Fire Safety Technical Design Note

**12 Park Road,
Hampton Wick, KT1
4AS.**

6th February 2023

Means of Escape in Common Areas

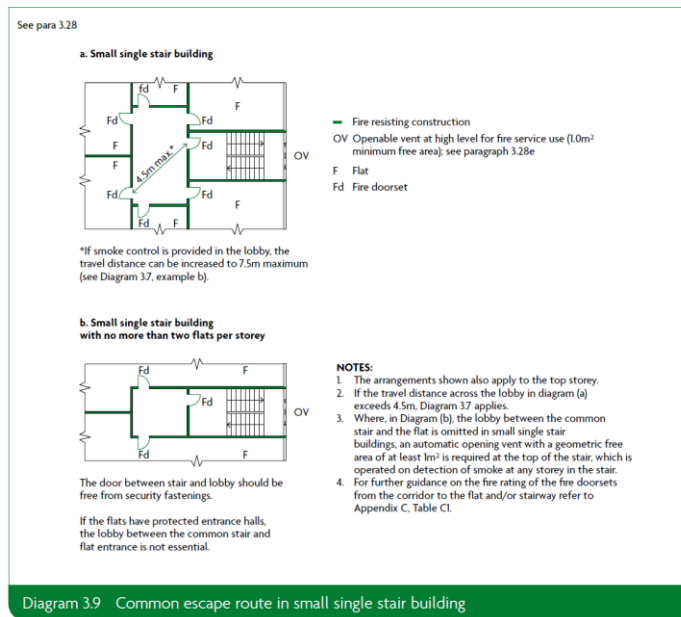
The store room at ground floor and cycle stands at ground and first floor should be removed, accessed externally only, or separated from the staircase by a ventilated lobby (min of 0.4m² permanent ventilation) The cycle stands should be removed.

The GA plans currently show an apartment at second-floor level, which is accessed via a short set of steps within the apartment leading to the first-floor of the staircase. This effectively provides the ground floor with 2 apartments and the first-floor with 3 apartments, which is not in accordance with the recommendations of ADB.

In the diagrams above, the green shaded area represents the communal protected staircase enclosure, the red circled door in Figure 4 should be removed, the red door in Figure 5 should be added and an AOV should be provided at the head of the stair. uppermost part of the stair.

The red circled door in the diagram should be removed to allow the AOV at the head of the stair to ventilate all areas of the staircase.

The red door in diagram contains the second-floor apartment to the second-floor and allows it to be accessed from that level. This resolves the issue of there being 3 apartments accessed from the first-floor.

It would be possible to reconfigure the design to locate the second-floor apartment on a single floor level accessed directly from the protected staircase at the same level as the apartment.
